STATE OF NORTH CAROLINA
DEPARTMENT OF TRANSPORTATION

Subject: Request for Modification to Individual Section 404 and Section 401 Water Quality Certification for widening and new lane construction from US 74 Rockingham/Hamlet Bypass to US 220 Ellerbe Bypass in Richmond County. Federal Aid Project No. NHF-0220(4), State Project No. 8.1580802, Division 8, TIP Nos. R-3421A and B.

The purpose of this letter is to submit final drawings for modification of the Clean Water Act (CWA) Section 404 Individual Permit (IP) and Section 401 Water Quality Certification for R-3421A and B. Preliminary drawings for these sections were submitted with the original phased permit application.

SITE 1

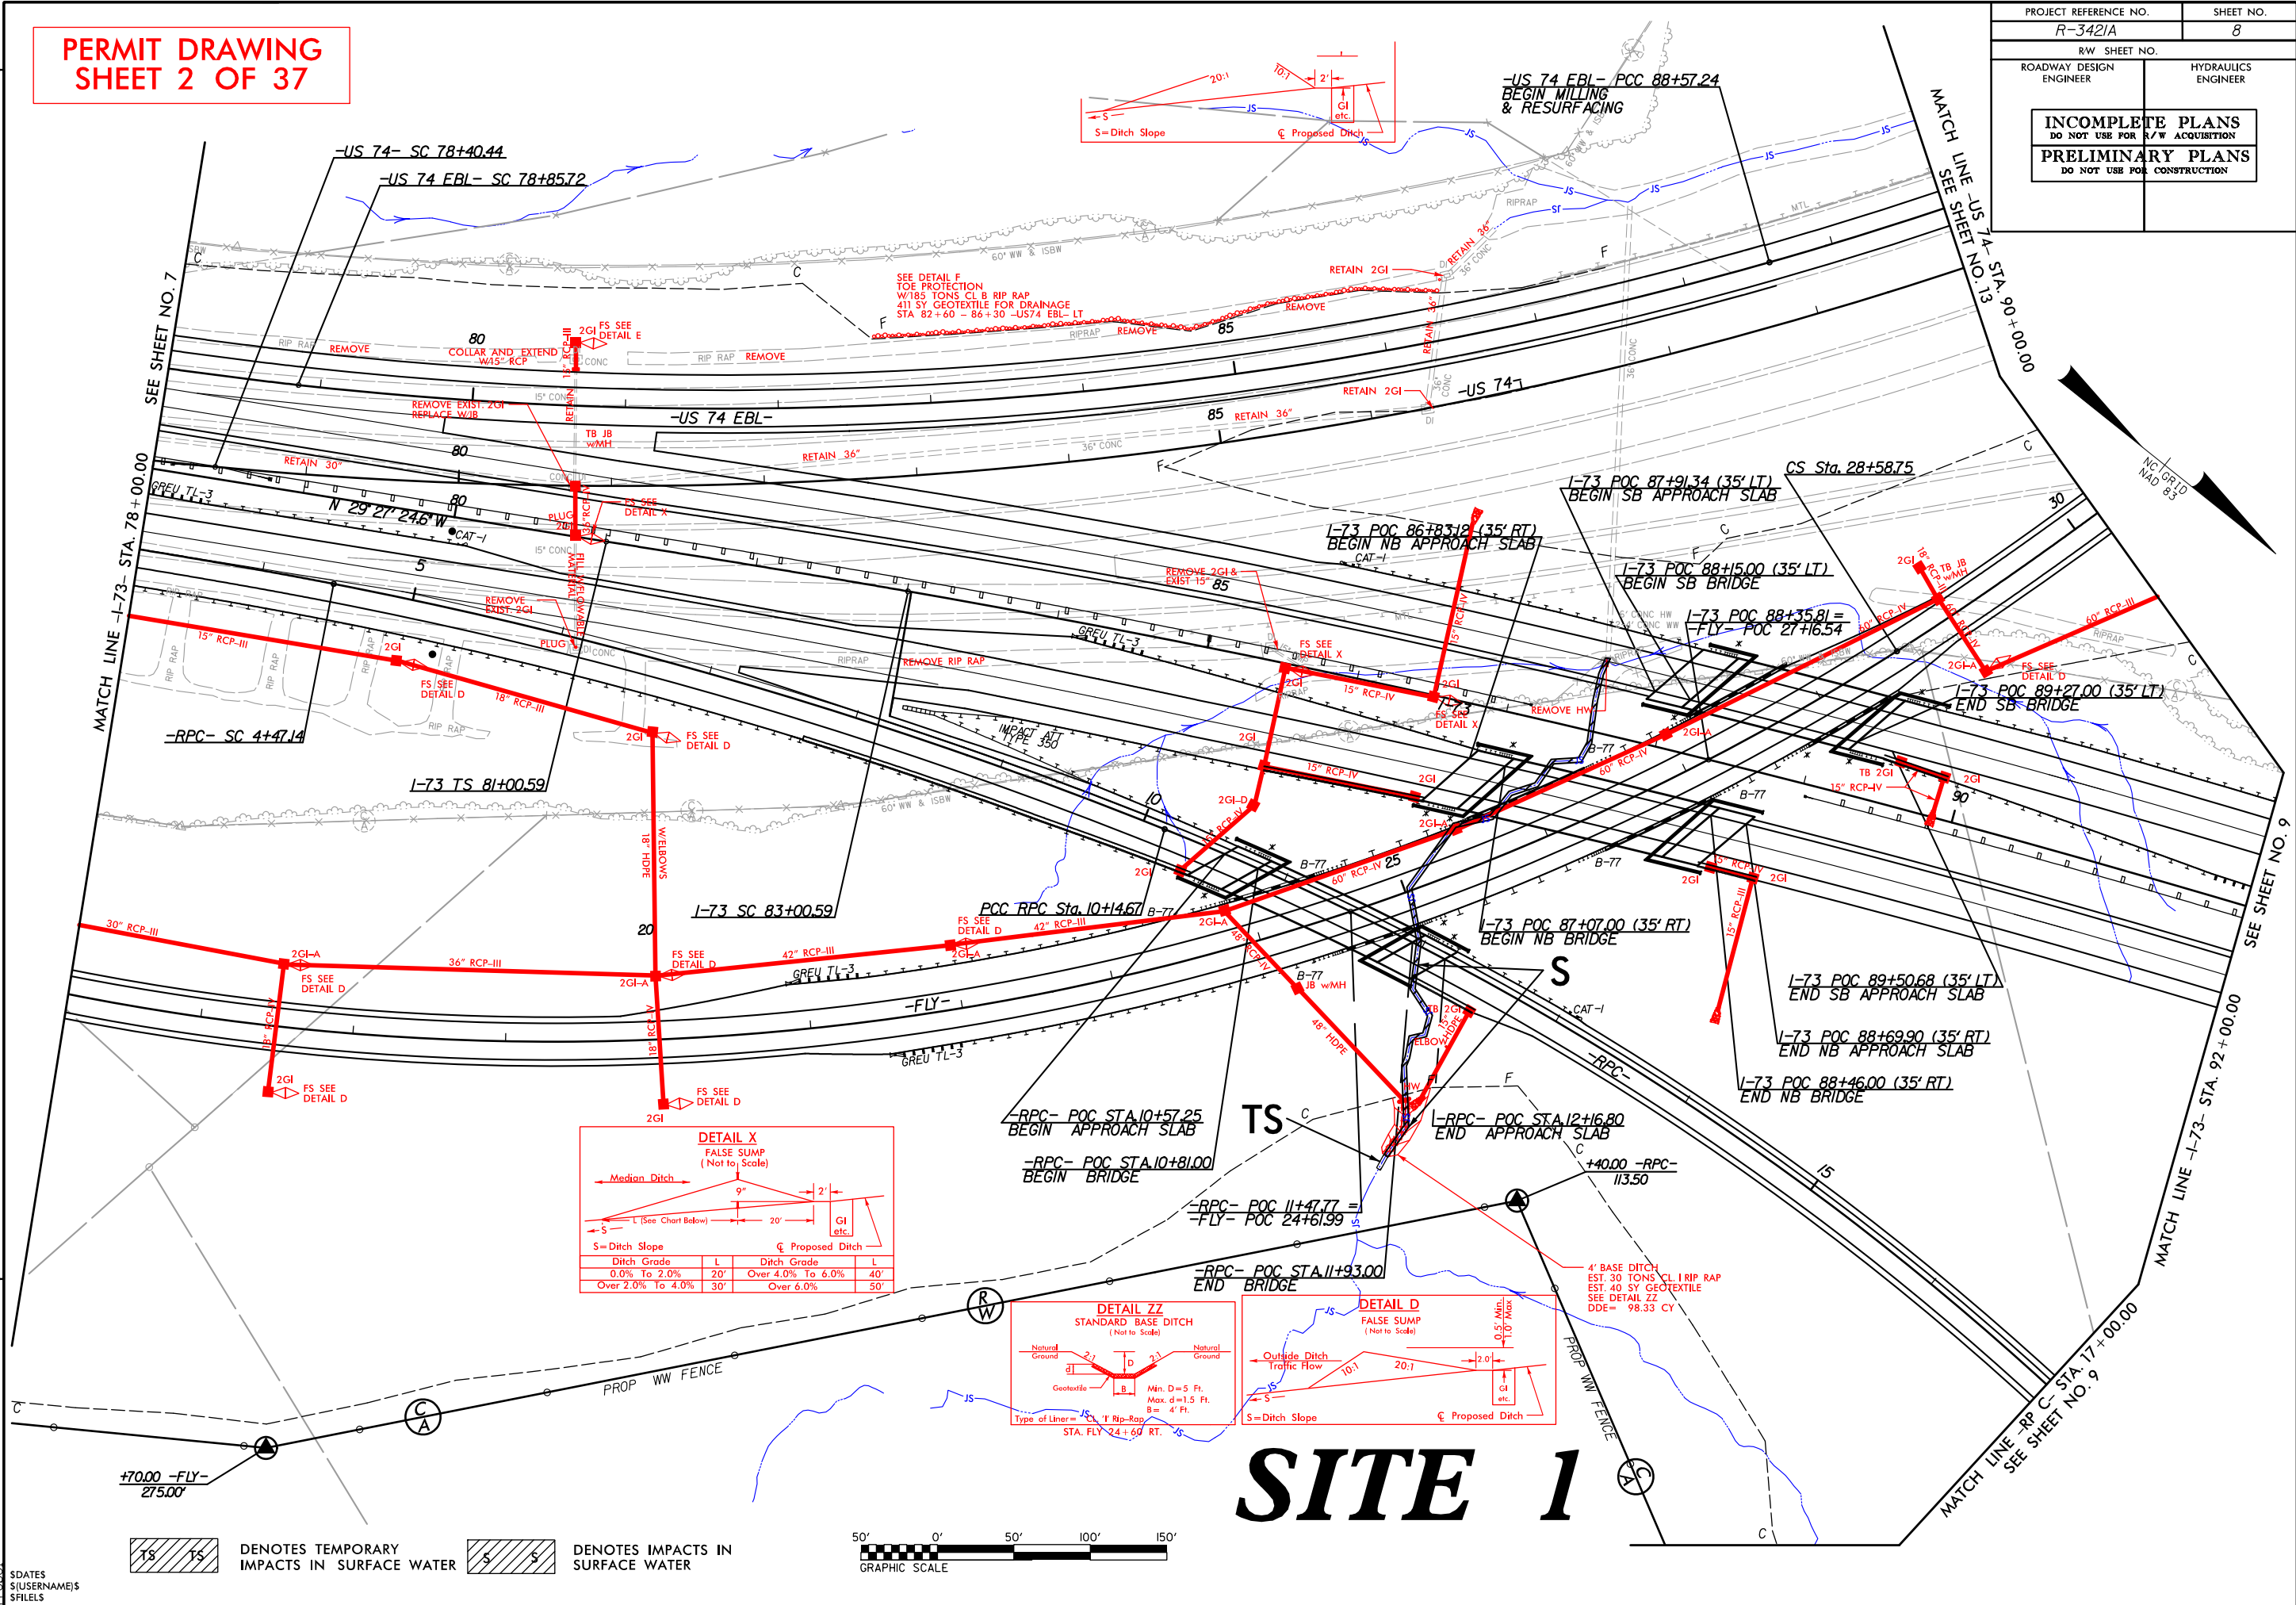
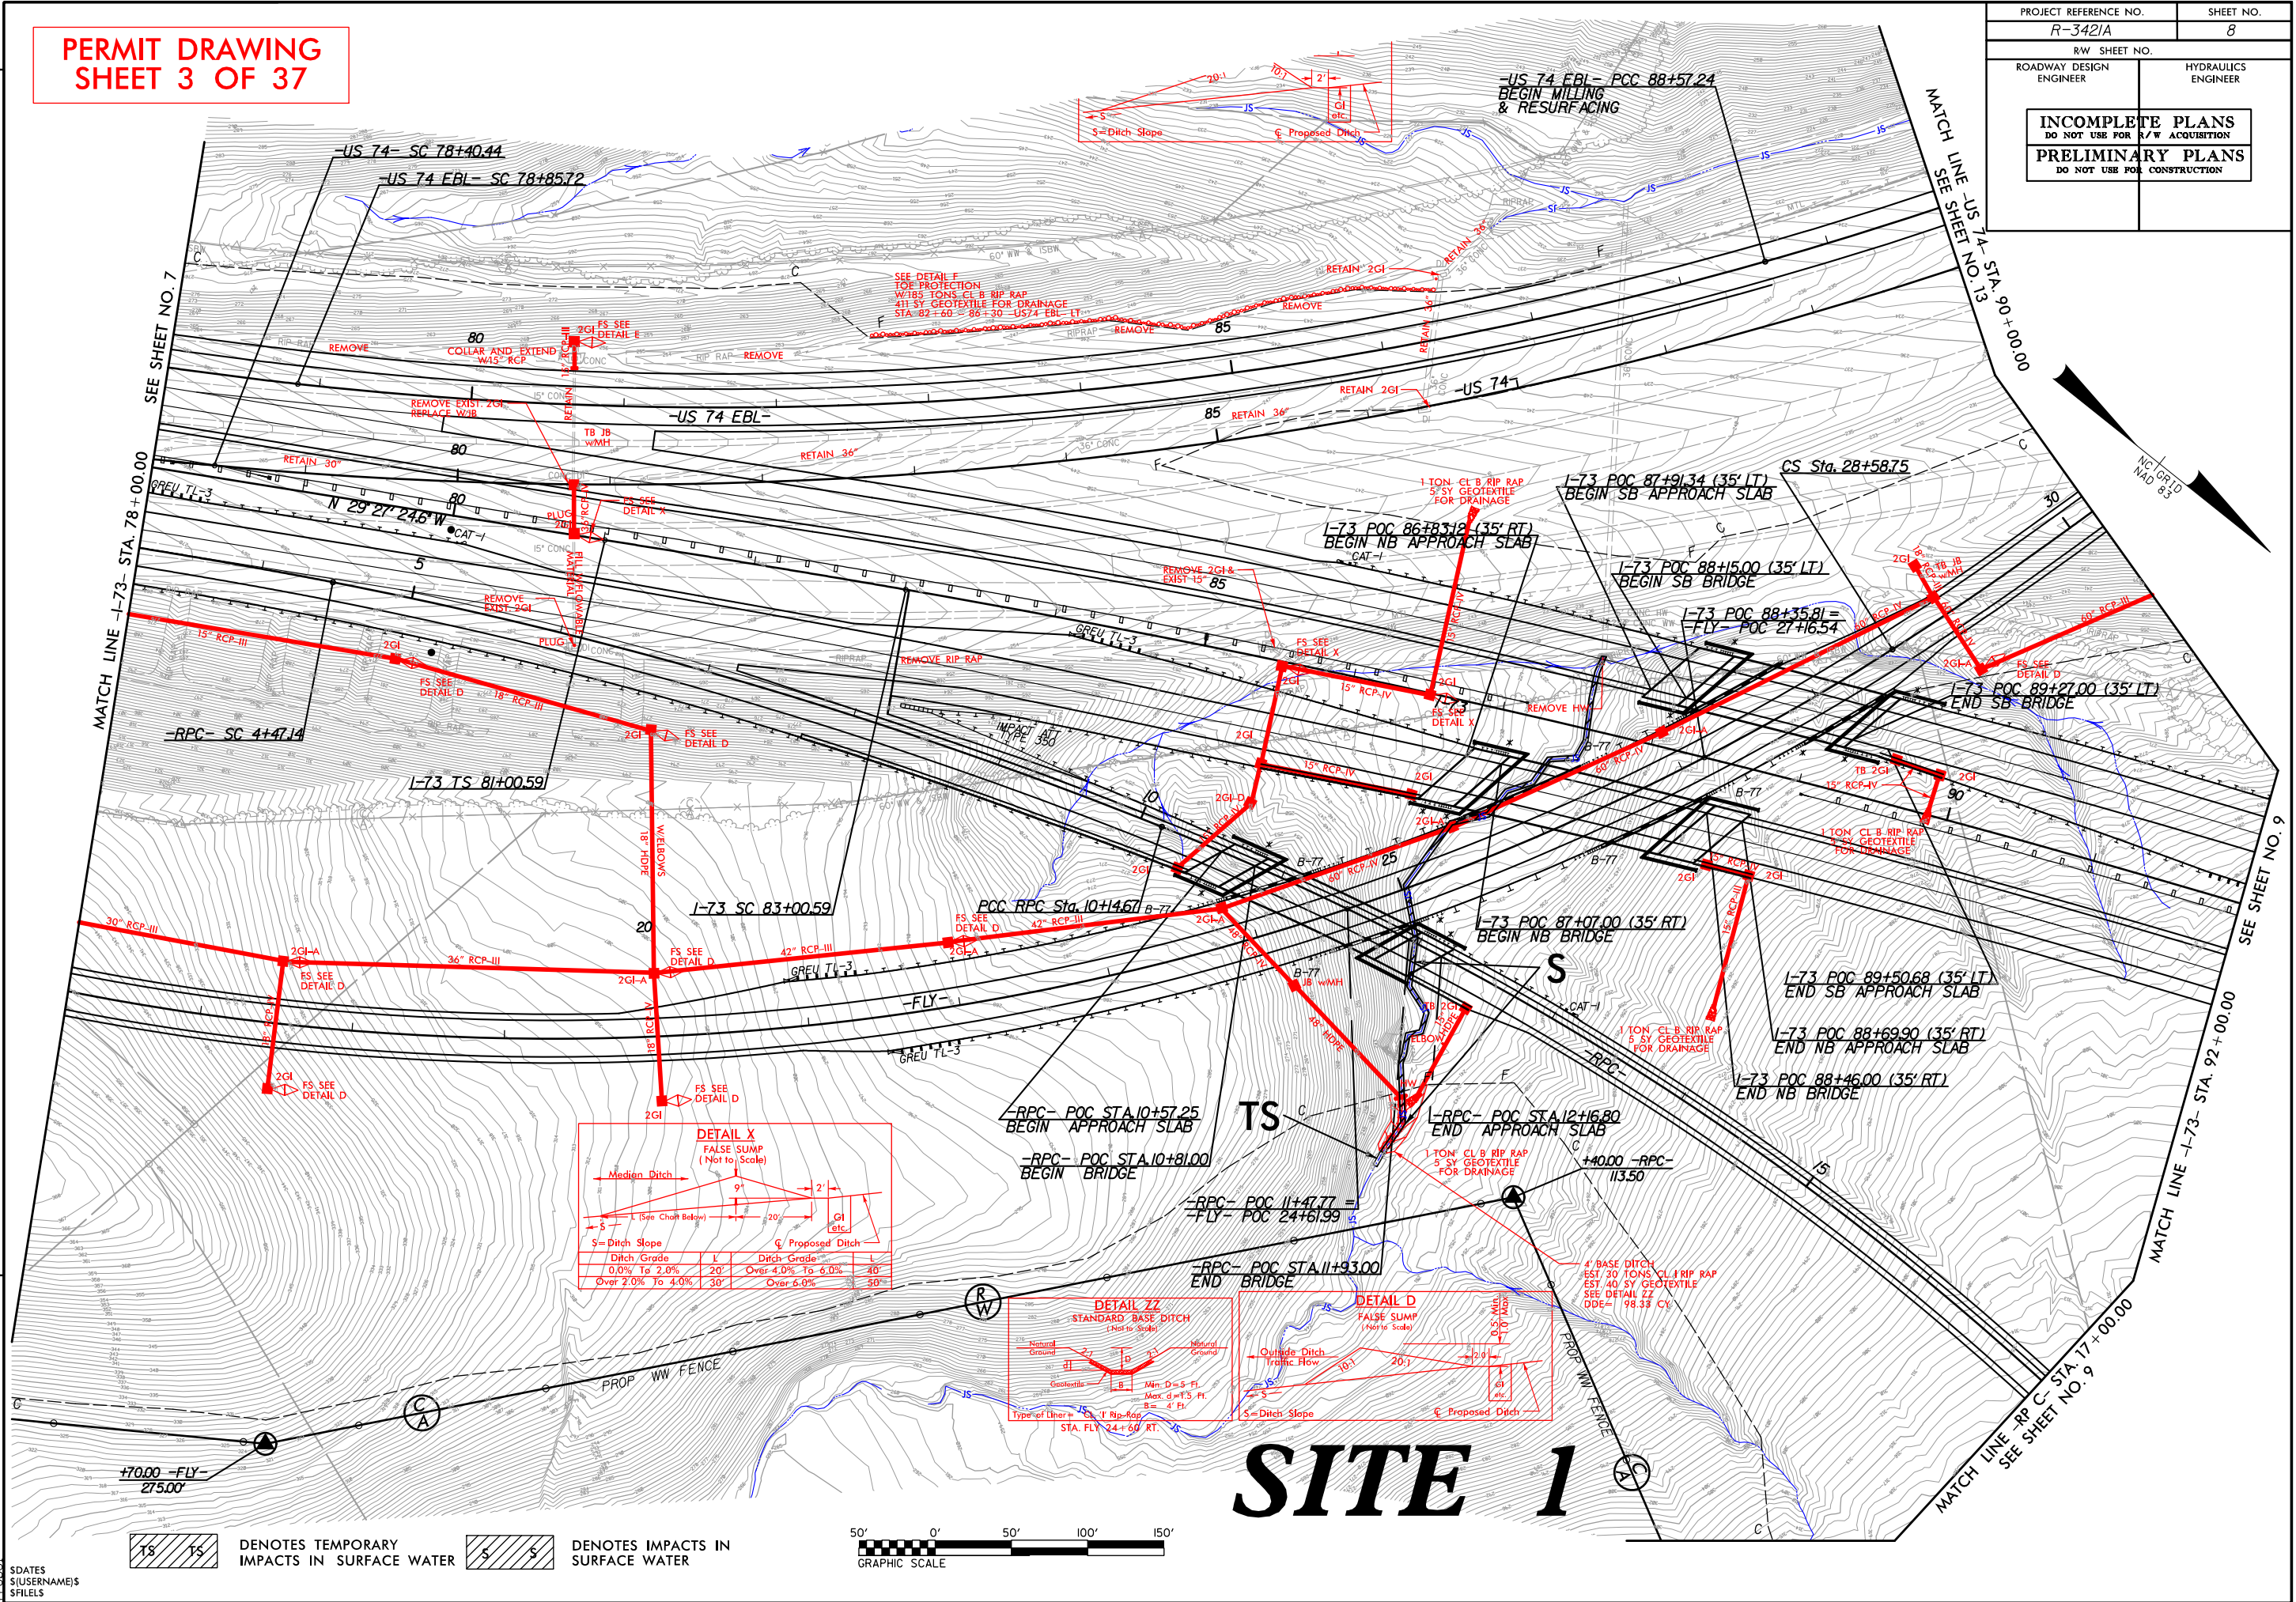
3. Permits – a Phased Individual Permit was issued in 2012 and expires December 2017.
4. Site 1
 - Note existing rip rap at outlet of 36" pipe.
 - Show Temporary Impacts at outlet of 36" pipe.

SITE 2 ENLARGEMENT

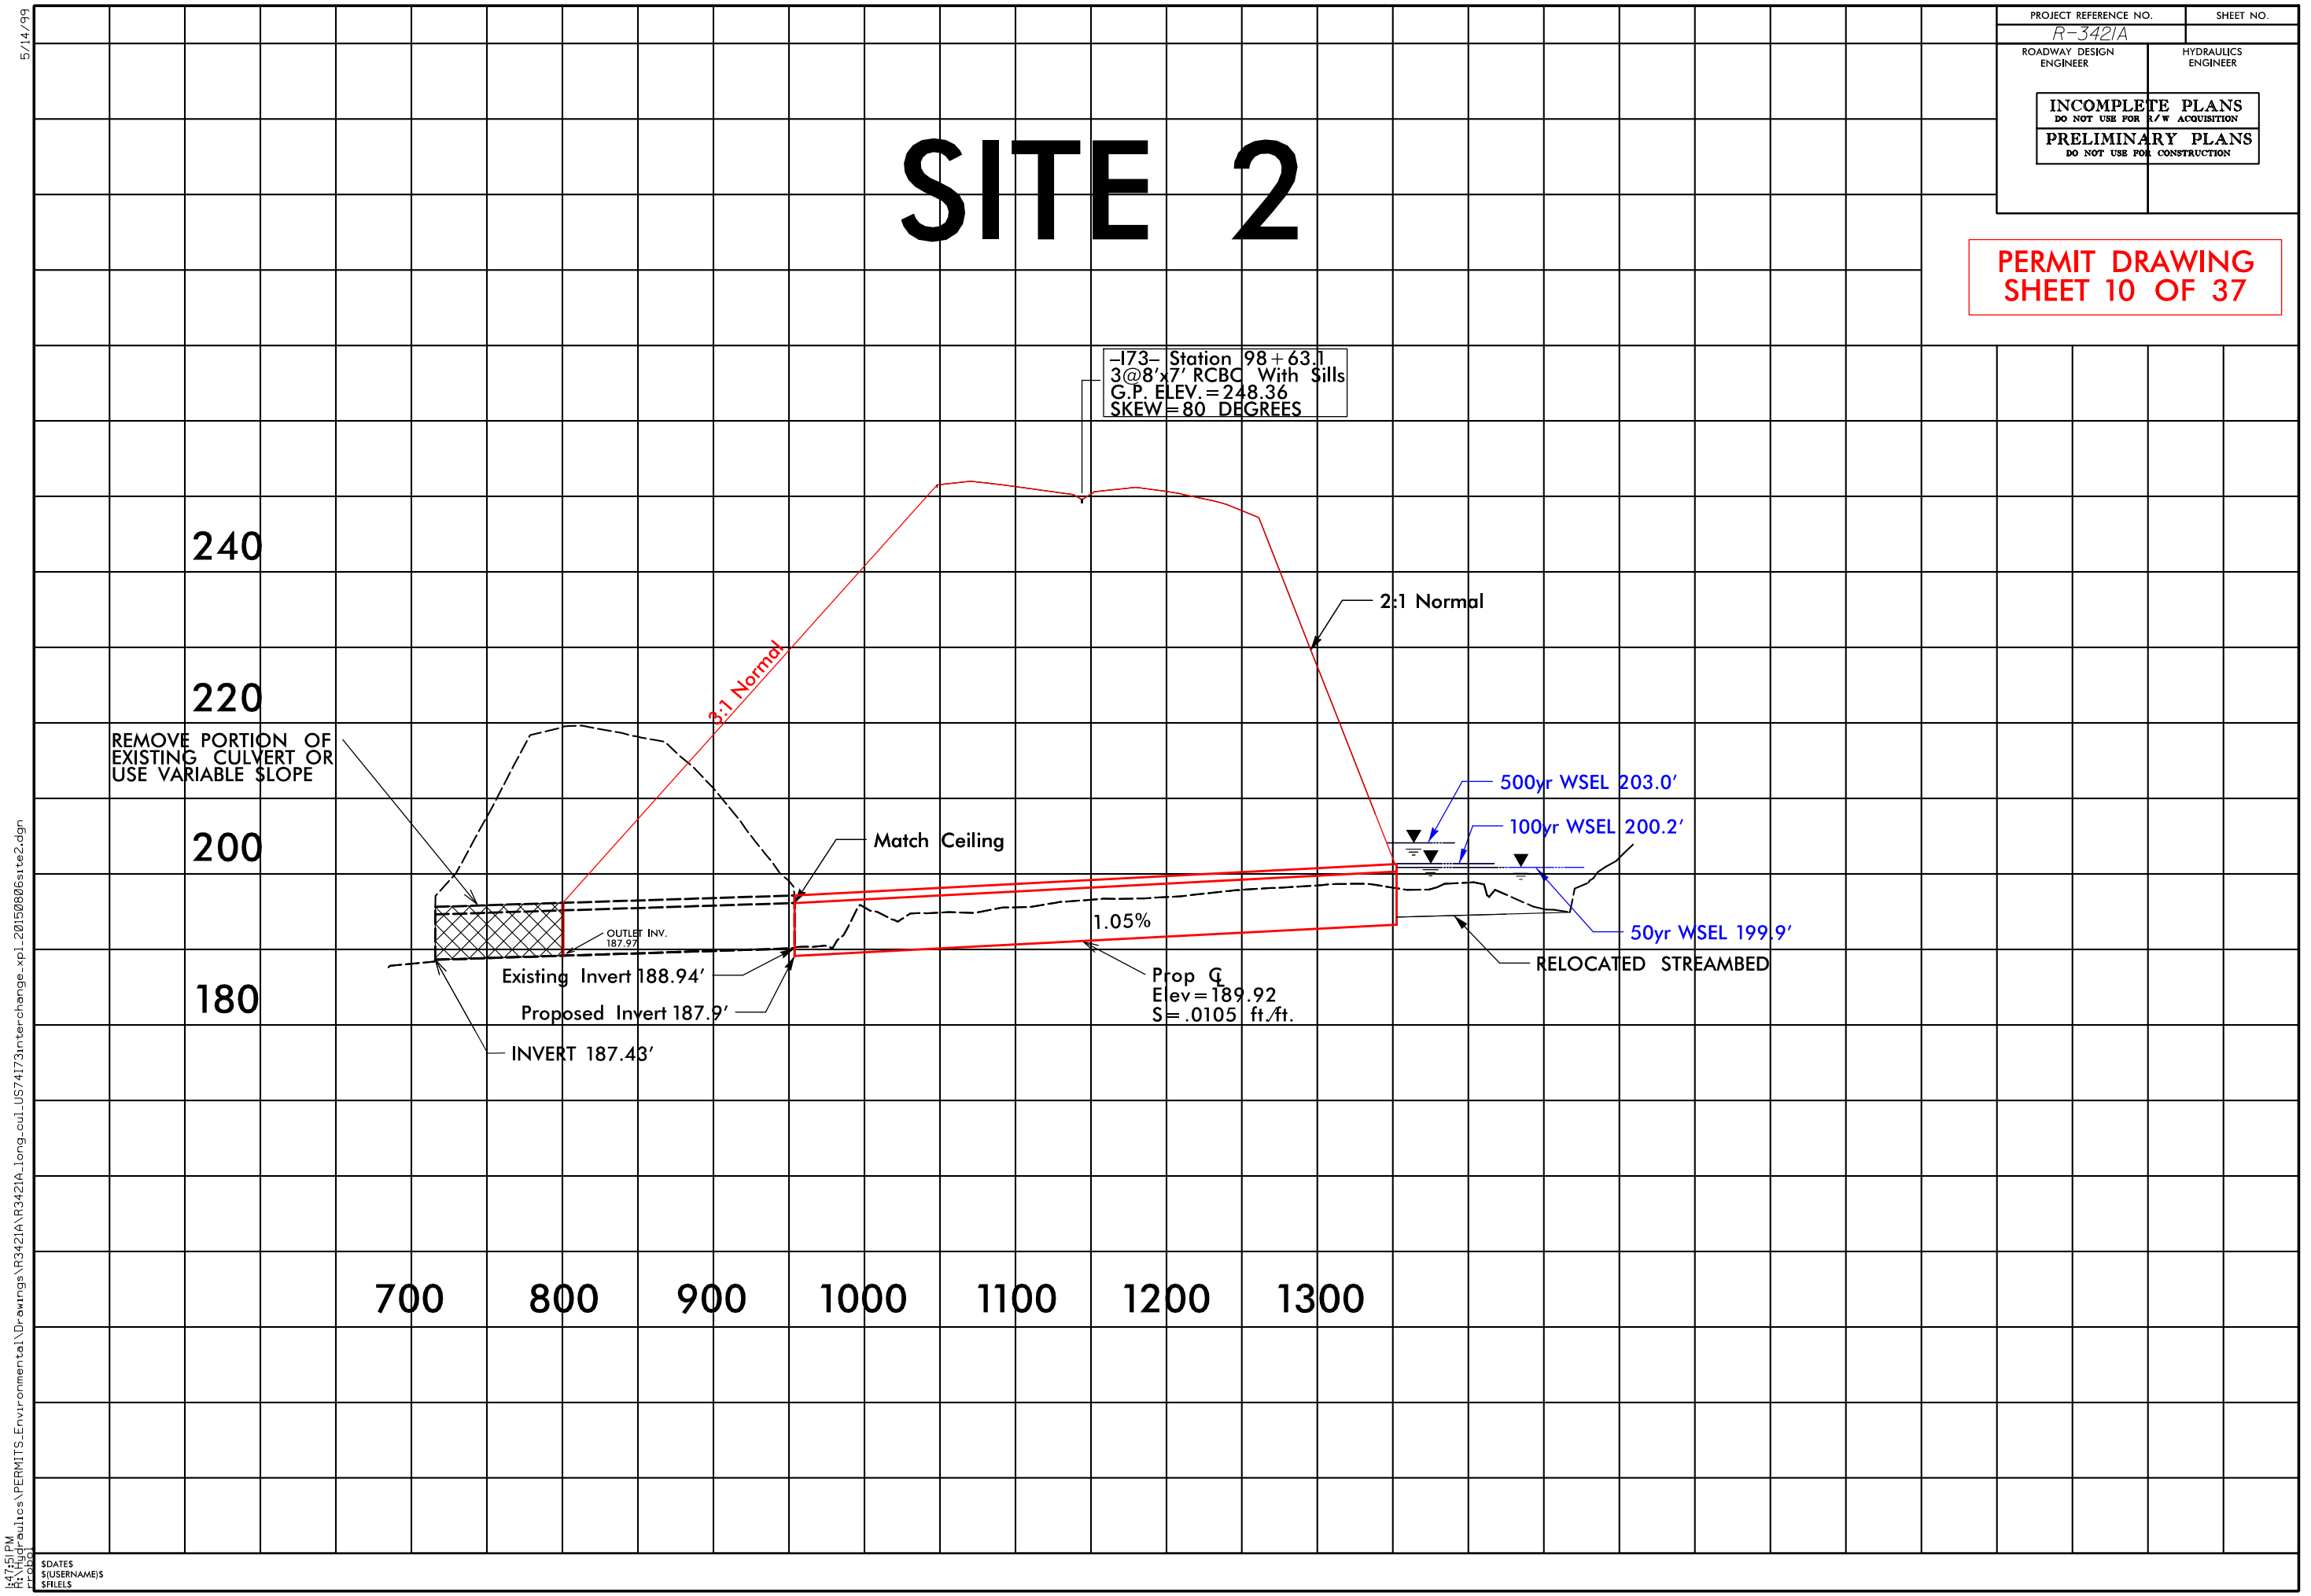
5. Site 2
 - Show stream as a total take between proposed culvert and culvert that will have a portion removed.
6. Site 3
 - Show Bank Stabilization at outlet of culvert at Loop C.
